SMARTElectrode 15.1.2.0

What's New

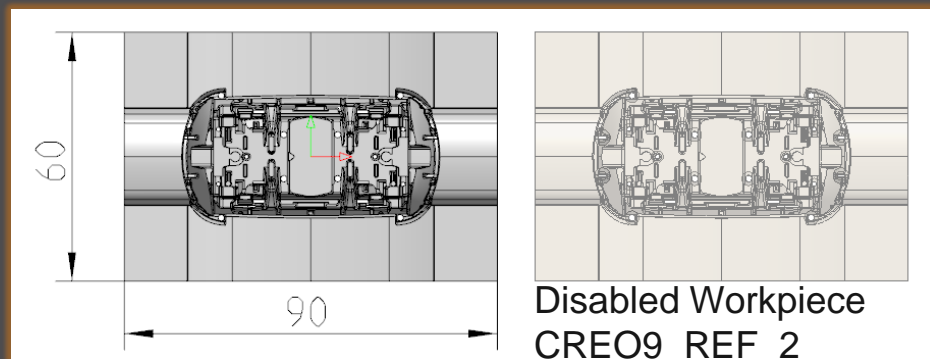
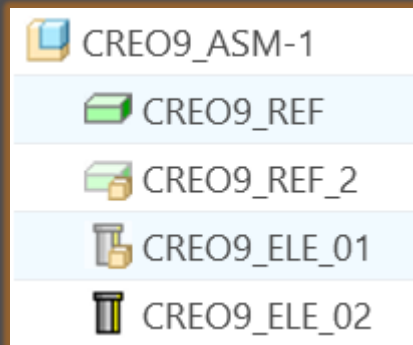
- Update simplified representations for enabled/disabled workpieces.
<https://redmine.buw-soft.de/issues/10294>

- Disabled workpieces should be hidden on drawing.
- Disabled workpieces shouldn't affect workpiece outline/dimensions

- Open Burnsheat UI and use context menu to enable/disable workpieces.

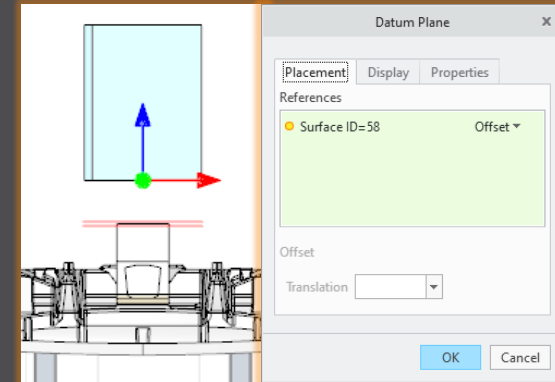
- Unlink FREE_FACE from default plane in assembly.
<https://redmine.buw-soft.de/issues/15655>

- FREE_FACE is currently an offset datum plane from operation's default plane.
- This leads to problems if the electrode is reused in a different assembly.
- FREE_FACE is frozen and can't be changed if original assembly is not in session.

- FREE_FACE is now an offset from a local datum plane removing the external reference.
- Modification also works in assemblies reusing the electrode.

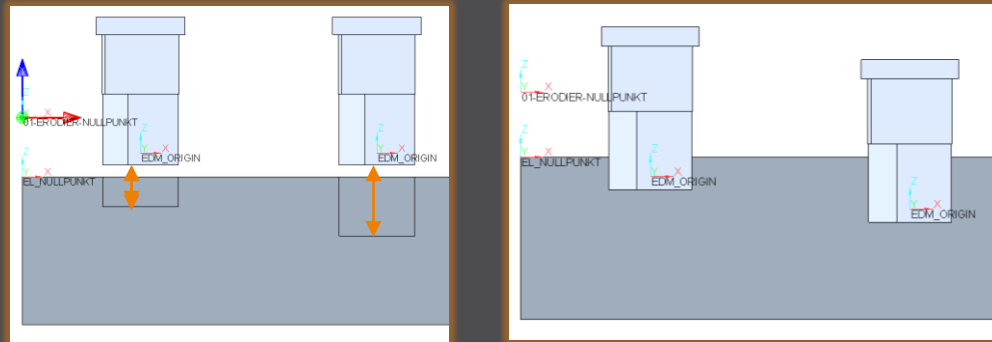
- Interface AC Form: possible wrong output of path from start to end position (PrepDepth).
- <https://redmine.buw-soft.de/issues/14918>

- electrode with more than one position.
- one or more electrode positions differ in start or end position.

Each electrode position is exported as a new shape to avoid this problem.

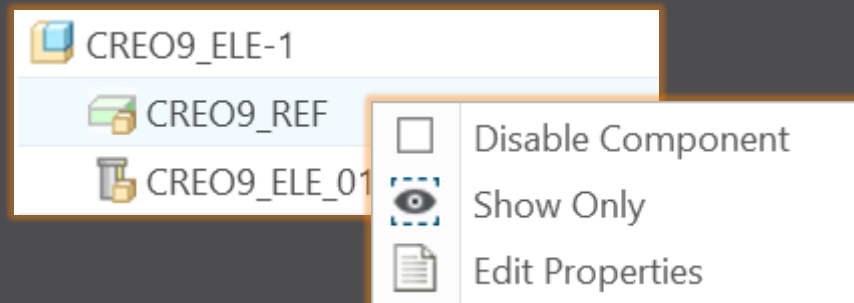
- Disable workpieces or electrodes in Burnsheat UI.
- <https://redmine.buw-soft.de/issues/4595>

- Disable a design dummy. Especially when using electrode merge or mirror.
- Original position of an electrode should not be used in export.
- Use disabled auxiliary model to display a start-position.
- Disable outdated version of workpiece.

- Disabled components are ignored in export, collision check and touching surface analysis.
- Open Burnsheat UI and use right mouse button context menu to disable component.
- Disabled components are displayed with specific icons.

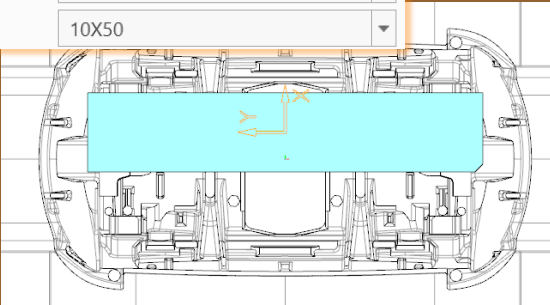
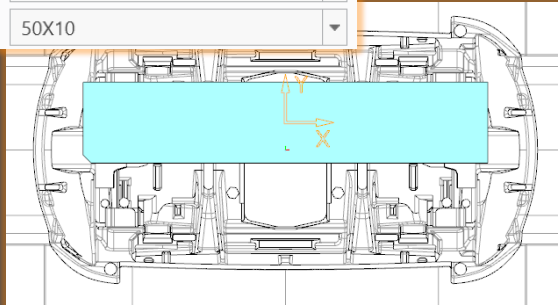
- Prefer template without rotation ($C=0^\circ$) if several templates with same blank dimensions are available.

- <https://redmine.buw-soft.de/issues/13672>
- Order of templates in .dat decided which template - with or without rotation - was assigned. This is improved by defined behavior.

Current Behavior

New Behavior

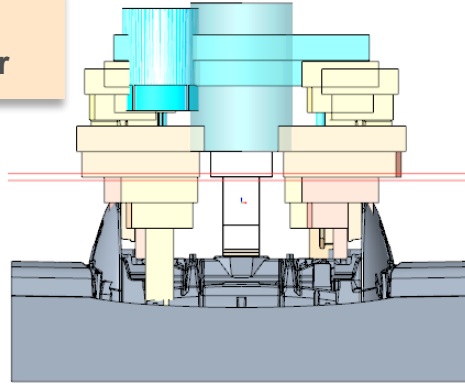
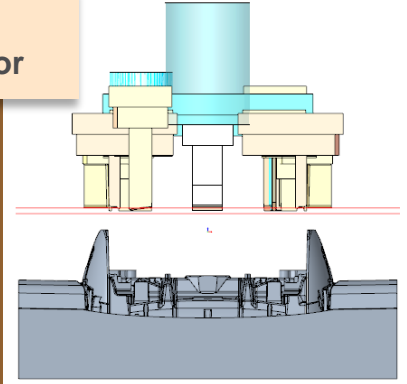
- BREAKING CHANGE
- Consider contour height on calculation of default start- and secure-position.
<https://redmine.buw-soft.de/issues/13762>

- Calculation of default start and secure position using EDM_ORIGIN led to disadvantageous or wrong values.
- Reduce effort to set start and secure positions.

- **NOTE:** Adjustment of operation default planes may be necessary to respond appropriately to the new behavior.
- New behavior is available for all assemblies from current versions.

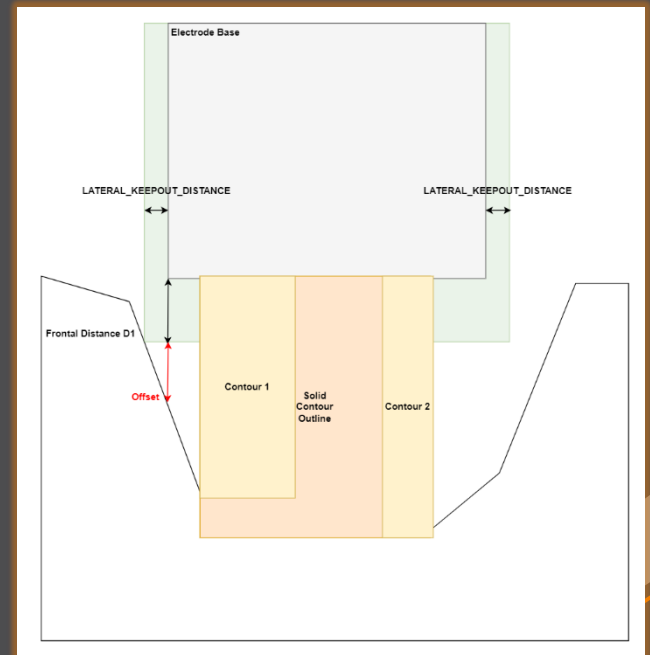
- Introduce new option #Electrode #LATERAL_KEEPOUT_DISTANCE
<https://redmine.buw-soft.de/issues/13766>

- Defines the minimum distance in XY direction from the base that must not be disturbed by workpiece geometry.

- Default value '0'
- When adding a new base, position will be adjusted to...
 - ...meet normal distance D1 and
 - ...to fulfill lateral offset defined in LATERAL_KEEPOUT_DISTANCE

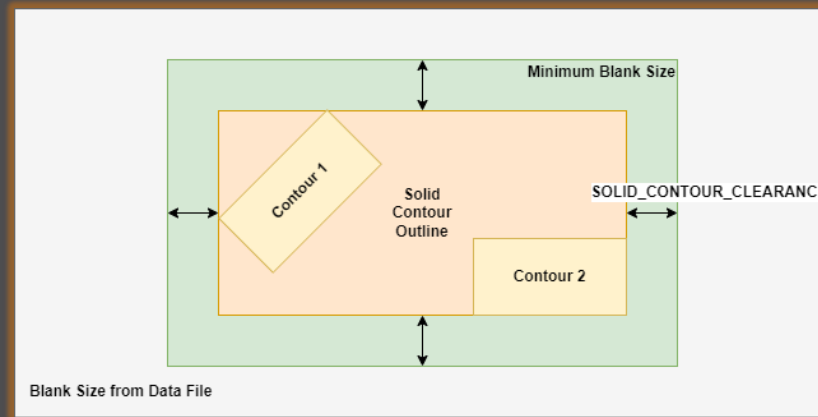
- Introduce new option #Electrode #SOLID_CONTOUR_CLEARANCE
<https://redmine.buw-soft.de/issues/13765>

- Necessary to specify the minimum clearance in XY direction between the contour and blank outline

- Option value SOLID_CONTOUR_CLEARANCE defines the clearance added to electrode's solid contour before blank size selection.
- Default value '0'
